City of Biddeford
Historic Preservation Commission

June 11, 2025 at 4:00 PM
City Hall Council Chambers & Zoom

HPC MEETING
May 14, 2025
Meeting Minutes
4:00
DRAFT

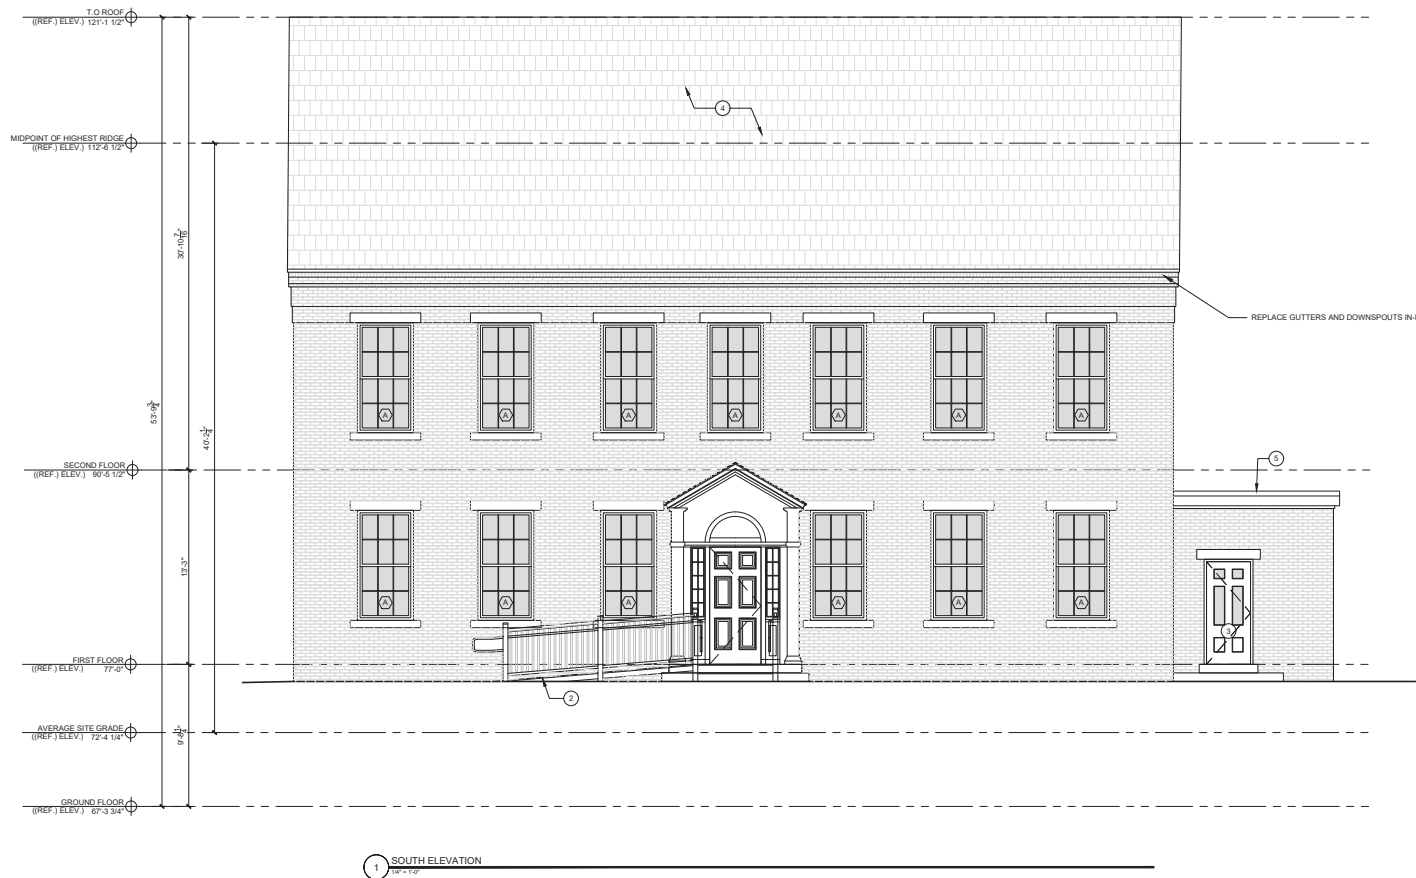
The ADA ramp proposed in front of the primary entry portico would change the historic character and appearance of the principal facade and main entrance to the building. Alternatives regarding the proposed location and/or design must be further explored. [CONDITION REVISED BY BDG]

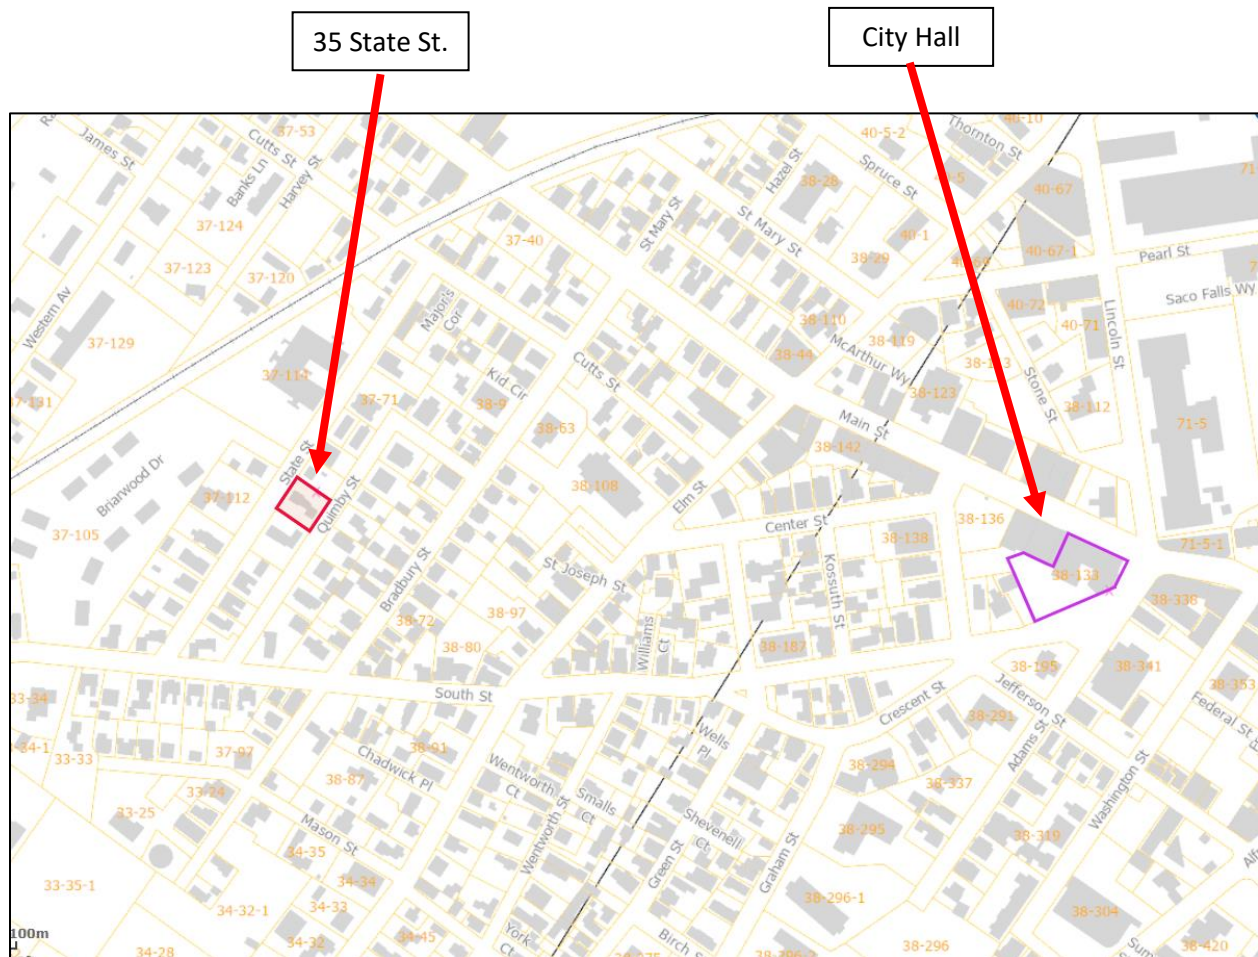
Proposed vinyl siding is a substitute material replacing historic material but may not destroy any distinguishing qualities or character. However, as stated on page 4, Figure 3 of Preservation Briefs 16, "Incremental repair is best done using in-kind material to minimize differences in the performance characteristics that could negatively affect the overall assembly."
